Appendix K:
Utica Harbor Point Redevelopment CM#2
Project, Existing Bulkhead Remedial Concepts,
CME, February 2015

Re: Utica - Harbor Point Redevelopment CM#2 Project
Existing Bulkhead Remedial Concepts
CME Report No. 26959E-02-0215
Page 1 of 2

Re: Utica - Harbor Point Redevelopment CM#2 Project
Canal Corp Inspection of Structure of September 19, 2008
CME Report No. 26959E-01-0215
Page 1 of 2

Annotations By:
MARCUS ROTUNDO
CME ASSOCIATES INC
2/10/2015

FINAL ESTIMATE Cost. Alteration No. 1

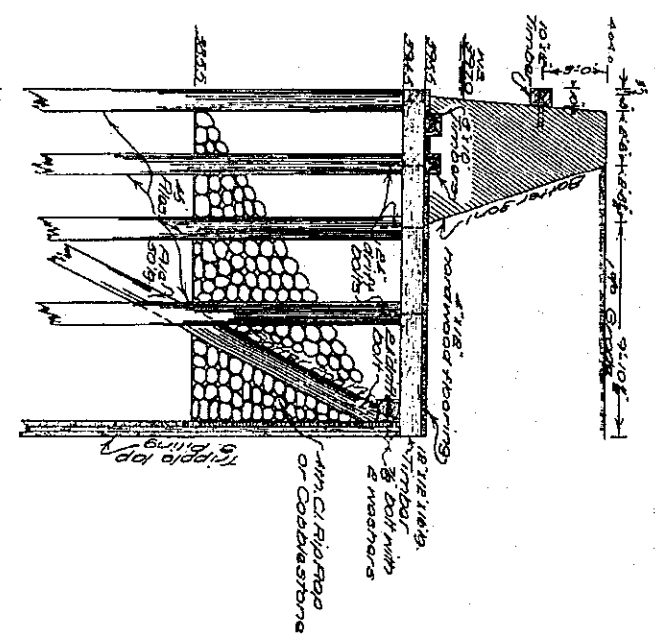
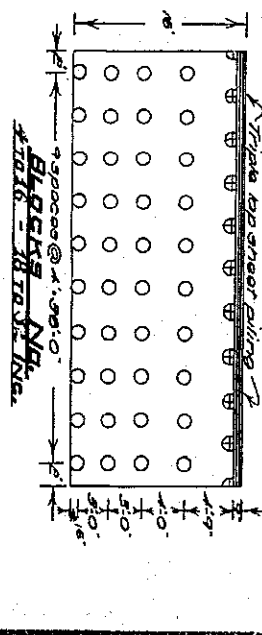
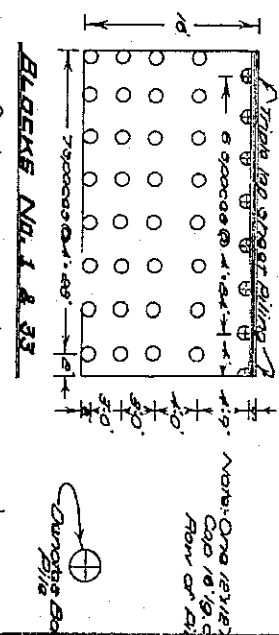
platform structure. Please refer to the attached January 1914, Final Estimate – Dock Alteration No. 1 Drawing for more information on what was planned to be built. It should be noted that the existing Dock and Wall does not conform exactly to this drawing. For example, the existing structure has about 100 piles less than what is shown in the 1914 Drawing.

I noted some apparent discrepancies between the January 1914 Final Estimate Dock Alteration No. 1 Documents and the Inspection Report of 2008. They are:

- The wood triple-lap sheeting may not exist or was not installed in 1914.
- The rip-rap may only be a few feet thick and laid on an earth slope.
- The rip-rap slope angle is likely steeper than shown on the 1914 Drawing.
- The piles are 4.25 feet on-center along the lines parallel with the existing concrete wall, not 4 feet on-center as shown on 1914 Drawing.
- One of the two 8x10 timbers to serve as keyways for the concrete wall, may be located at the outside face toe of Wall.

CONCEPT SKETCH

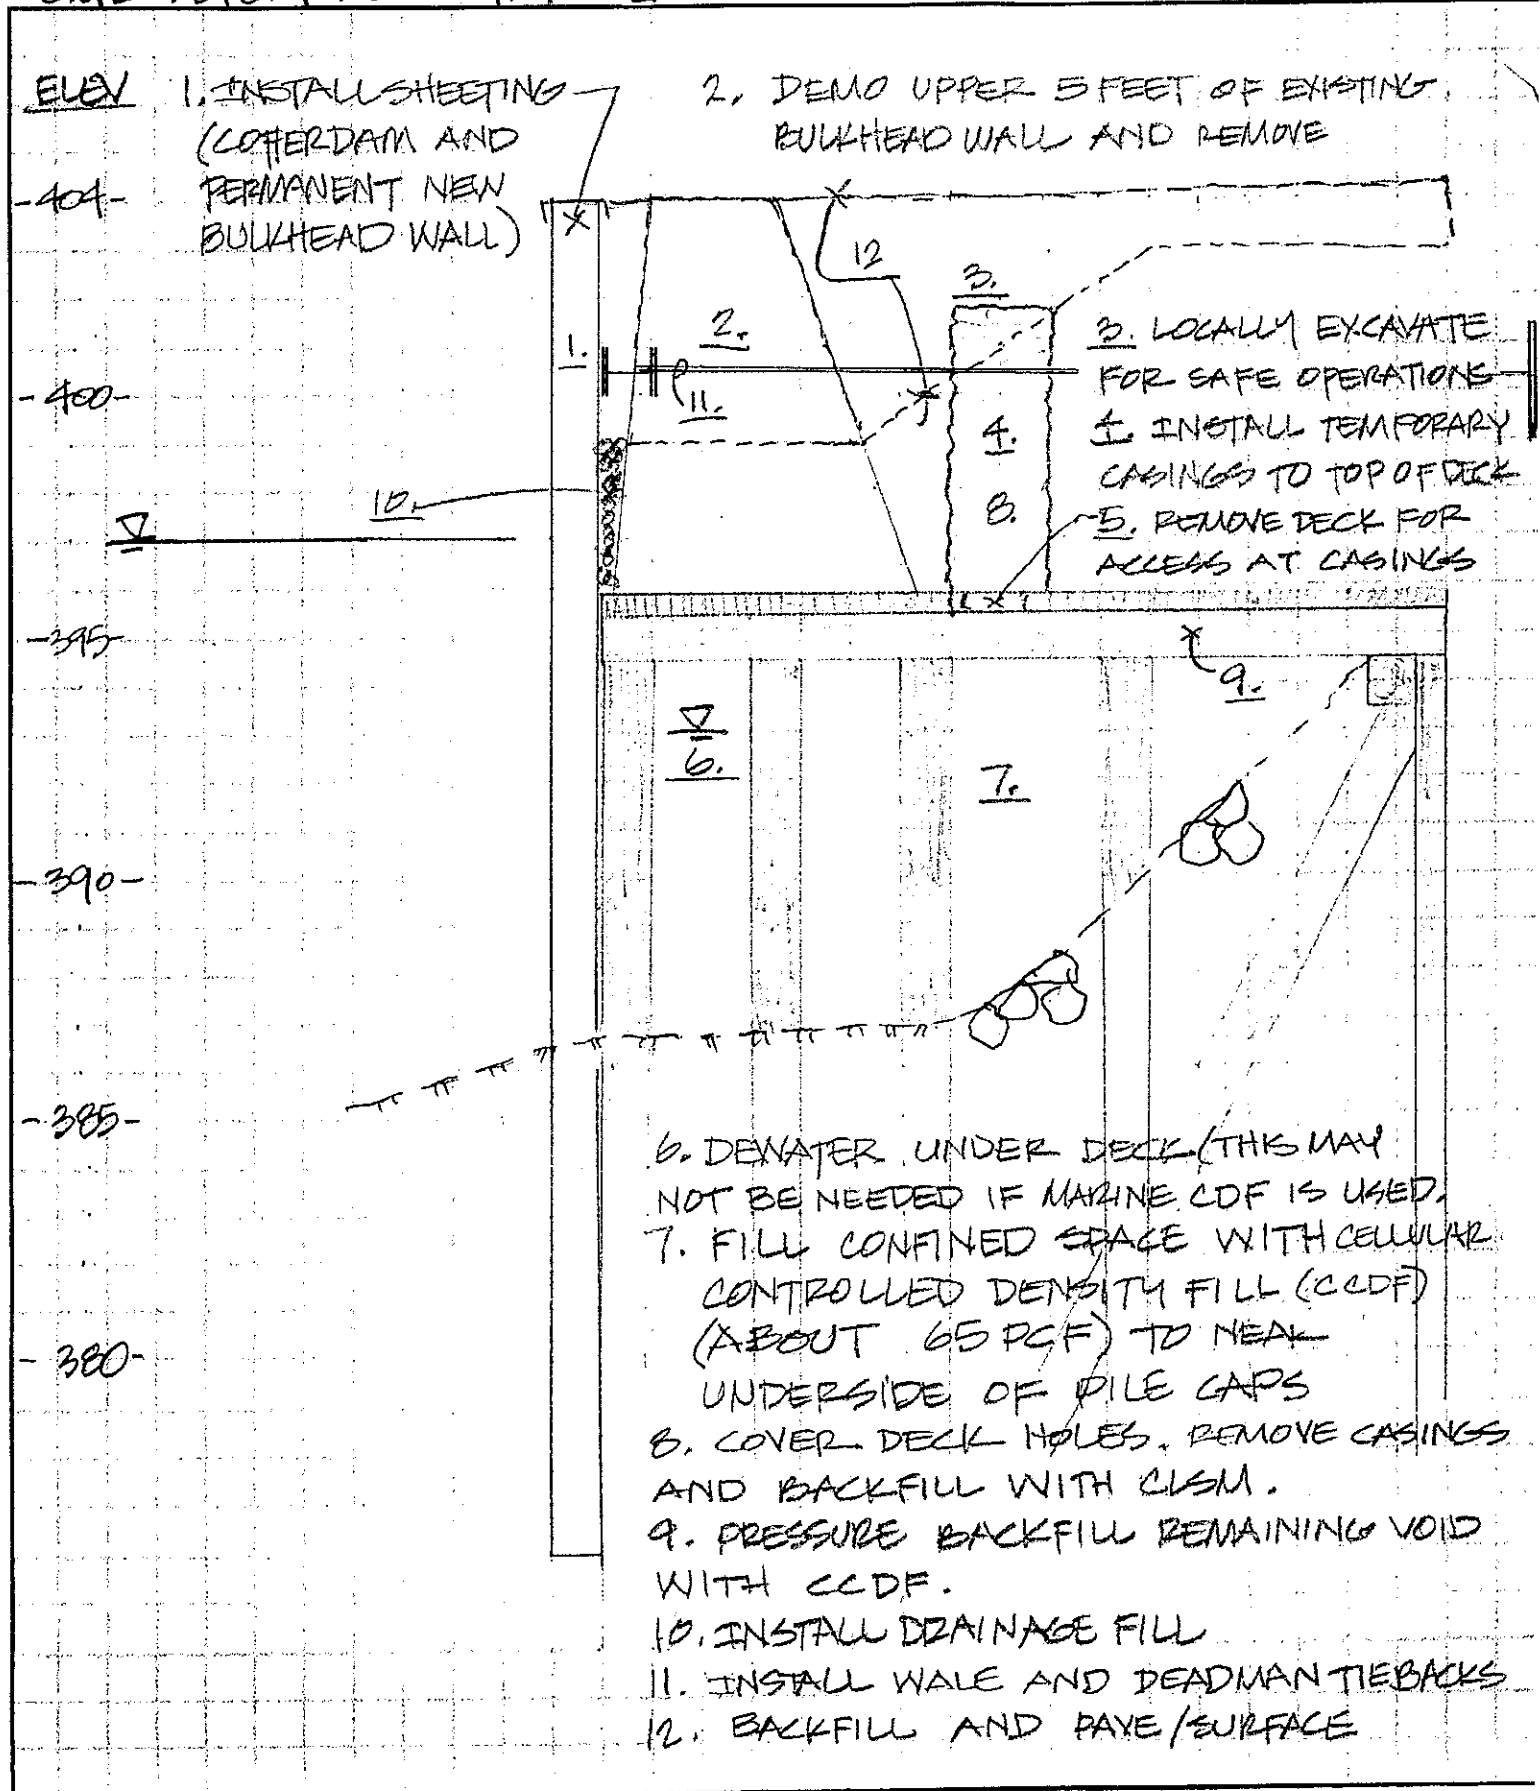
CME's second concept studied was to install a permanent light gauge sheetpile cofferdam wall, demolish a portion of existing concrete wall, partially dewater, and use Cellular Controlled Density Fill (CCDF) to fill the entire void space between the light gauge sheetpile wall and land under the deck. Install waler and deadman tiebacks for wall, backfill and pave/surface.

CME's second concept is presented on the attached sketch and is intended for discussion purposes. This concept is about 50% less costly than the first concept and, since the new Bulkhead Wall will be completely backfilled to the mudline, represents a much lower risk alternative by eliminating the sudden collapse and sinkhole risks.

It is recommended that the Concept Sketch be considered and discussed. If no other significantly different concepts are envisioned that capture the attributes desired, then Design Development of the concept should commence.

PLAN VIEW

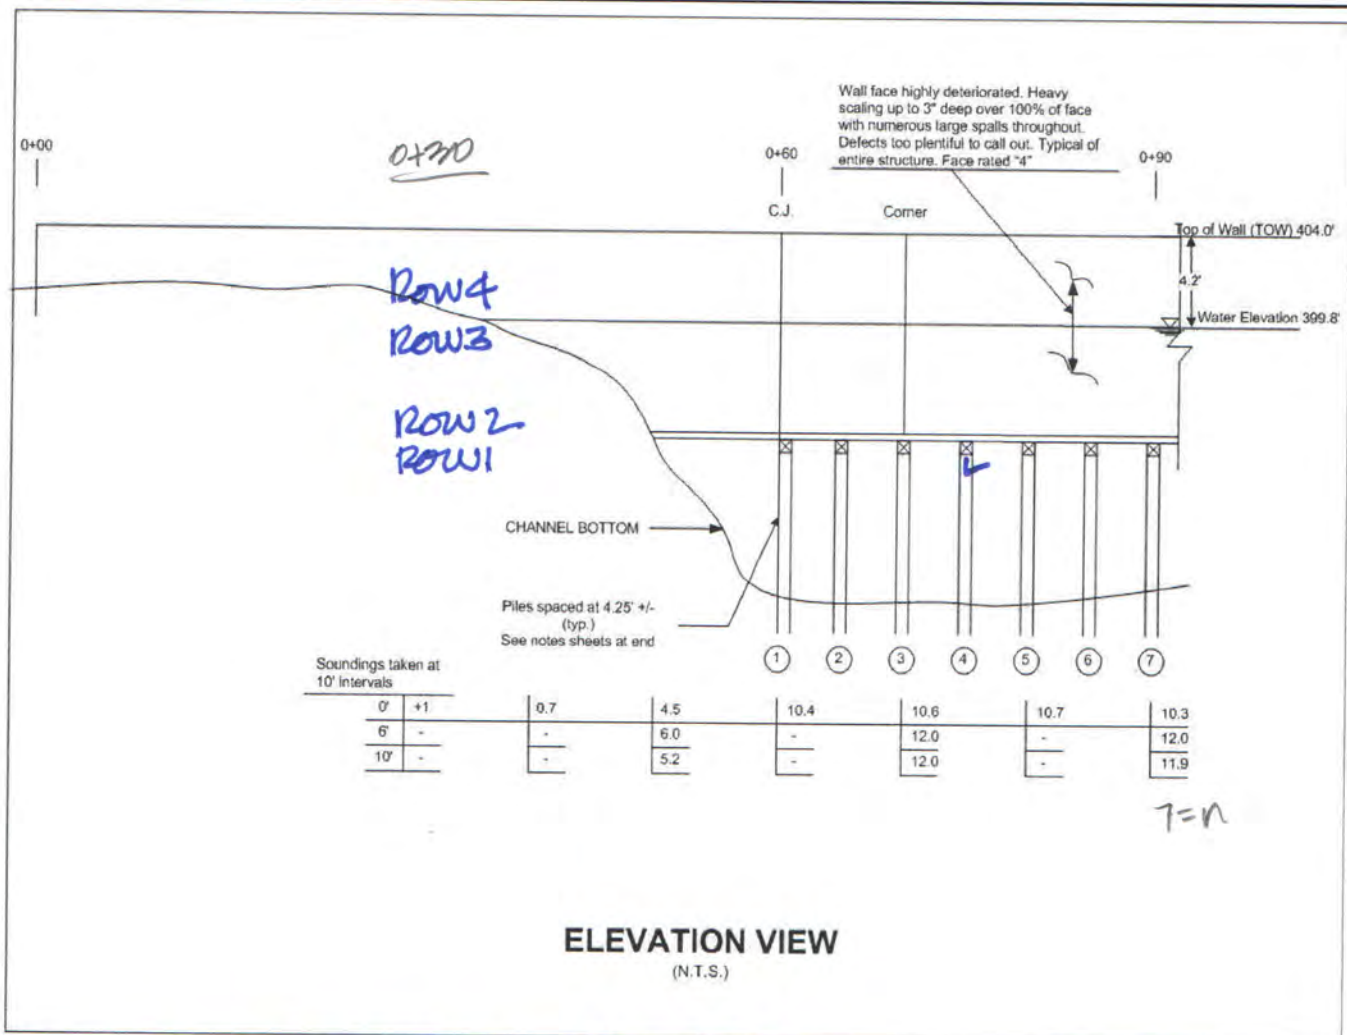
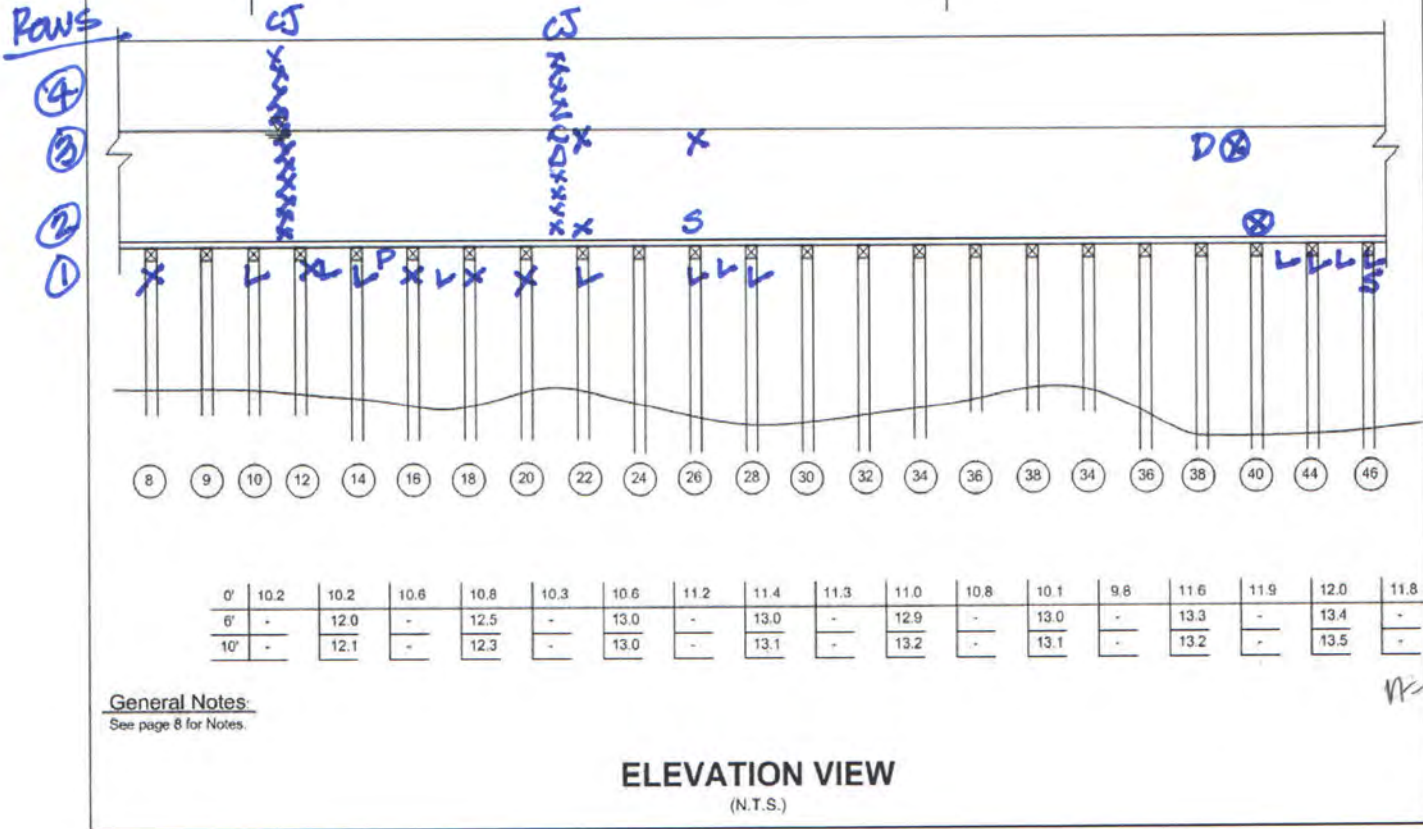
My Findings are presented in Table 1. Row 1 is at the outboard toe of existing Bulkhead Wall.

- L- Cross Section Loss 10% or More
- D- Displaced Horizontally
- ⊗- No Contact with Pile Cap or ≥ 75% Barring Impaired
- X- Barring Impaired 50% or more
- S- Pile Cap - crushed/split or split Pile

ELEVATION VIEW

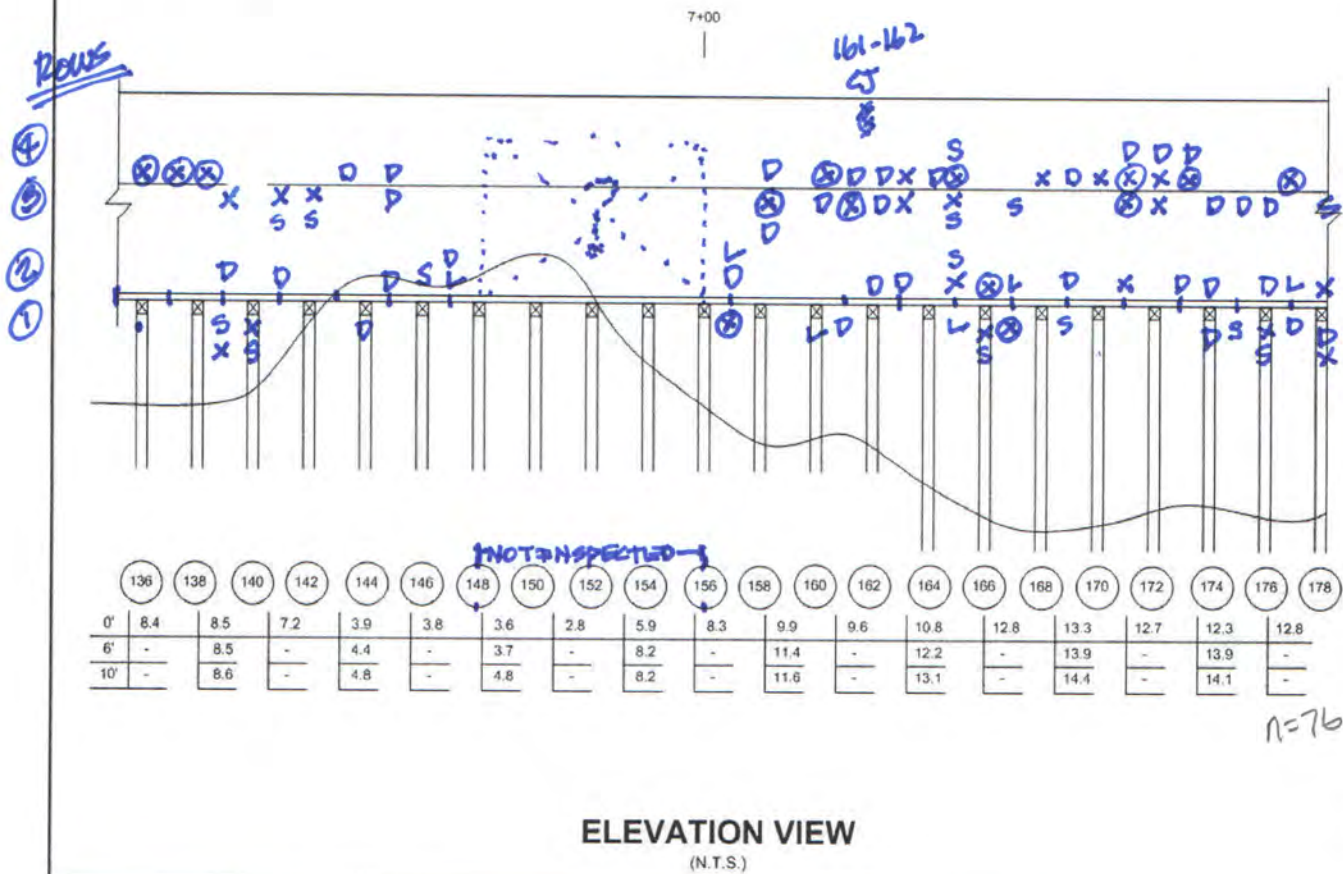
139 ① Crushed

140 ① Crushed

148-156 All Rows - Not Inspected

ELEVATION VIEW

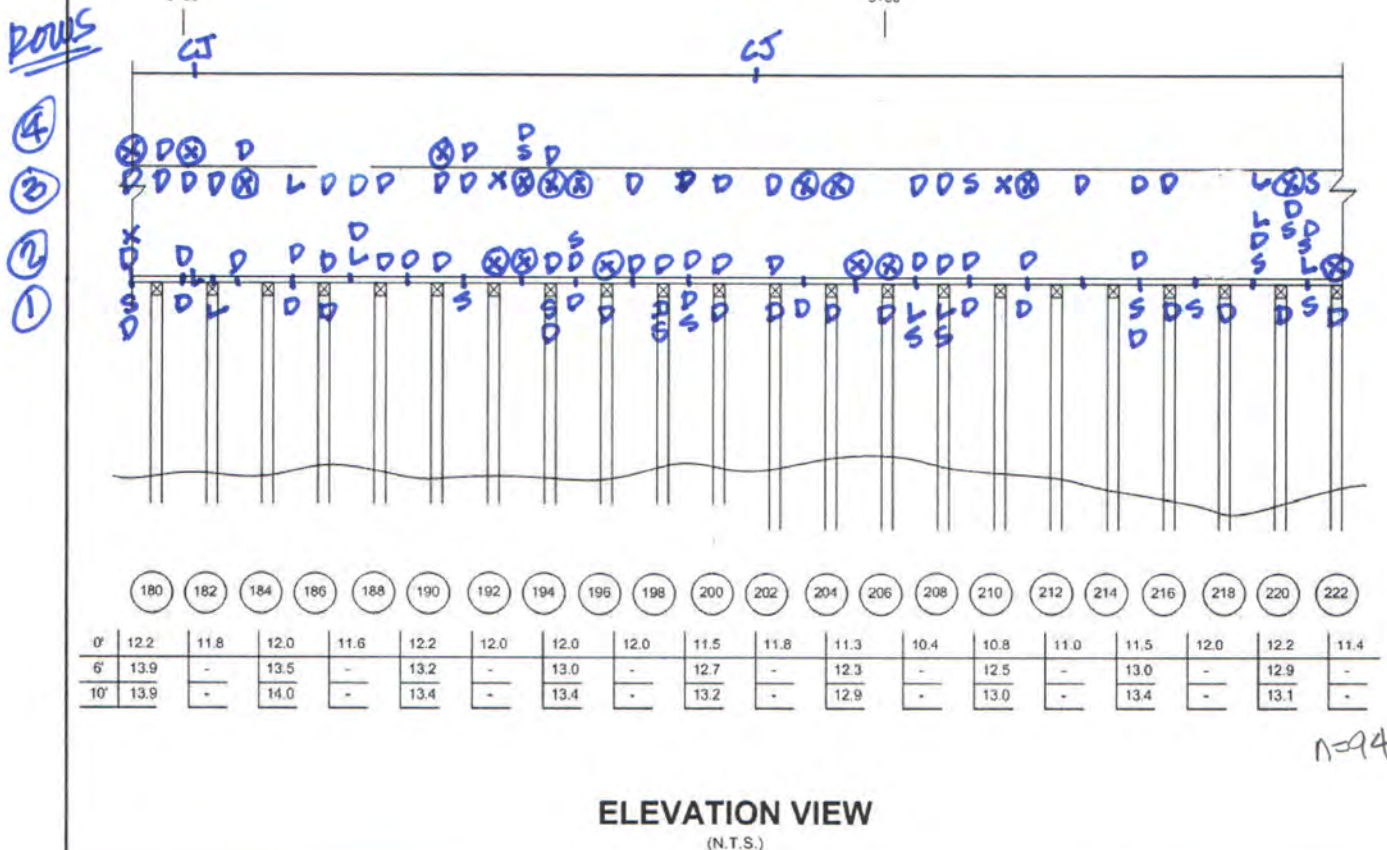
157 - Drain Pipe

161-162 - CS poor condition

174 - Sheet Pile?

181-182 CJ - spalled

181-182 - Beam between pile caps 50% loss-x

179-180 - do

ELEVATION VIEW

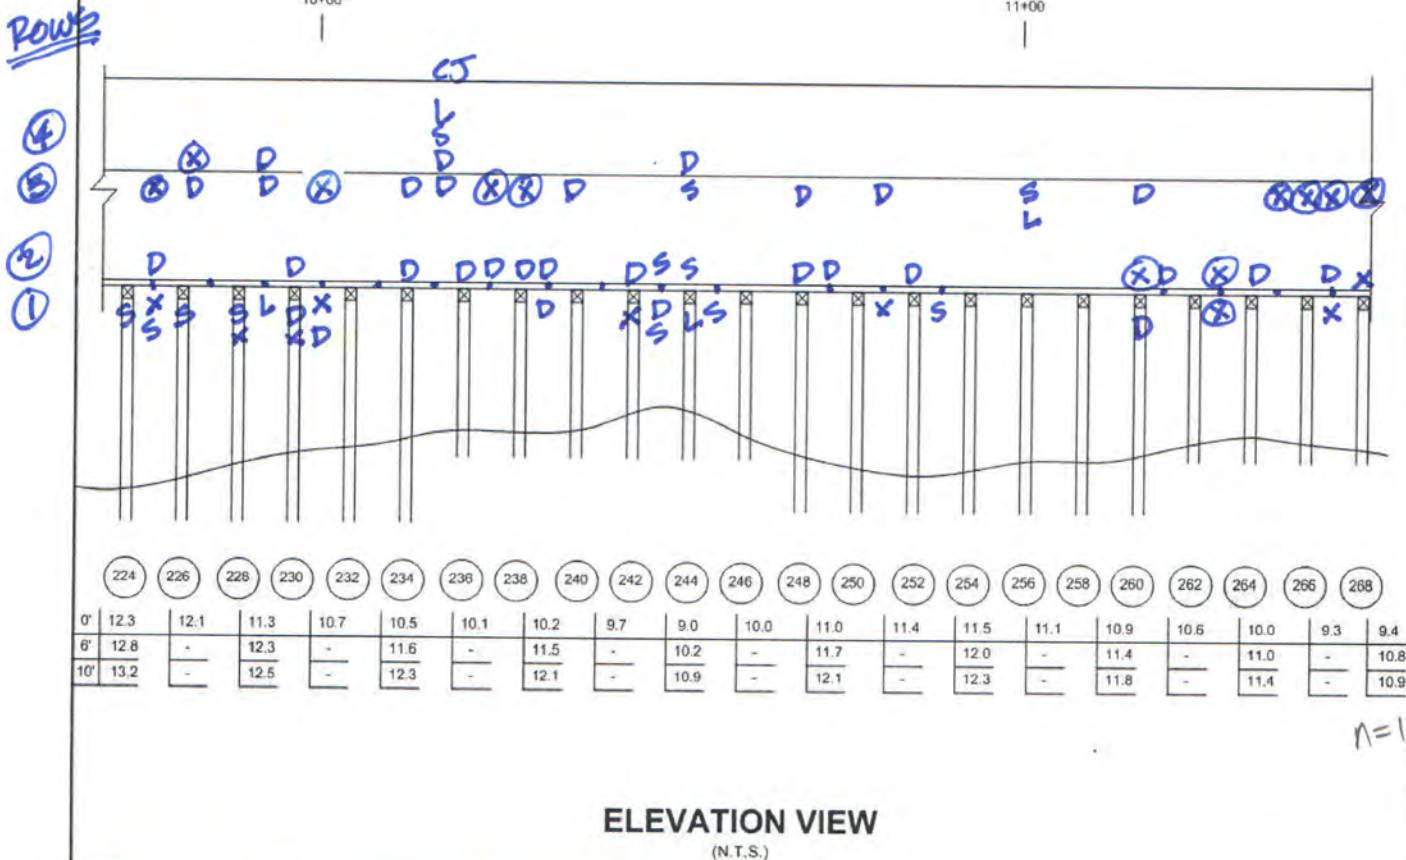
201-202 CJ - spalled

216-217 Beam broken

221 - End Cap Split

233 - ② Rip-Rap to Row 2 on angle

234-235 - CT - 50% Section Loss, spalling to bottom

237 - same as old report

240 ③ Rip-Rap

241 - ?

242 ④ Rip Rap

244-245 Penetrating hole goes up @ 45° angle

246 ③ Rip Rap

249 ④ Rip Rap @ 393±

255 ⑤ Rip-Rap

ELEVATION VIEW

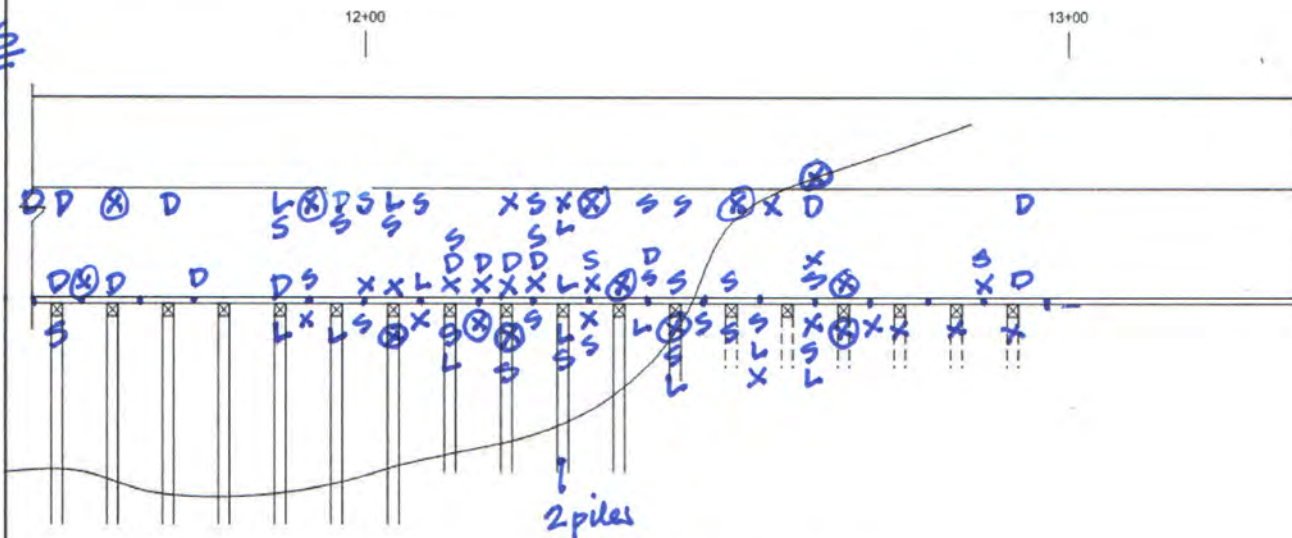
260 ③ Rip-Rap

294-③ kip-Rap

301-③ kip-Rap

303-① kip-Rap
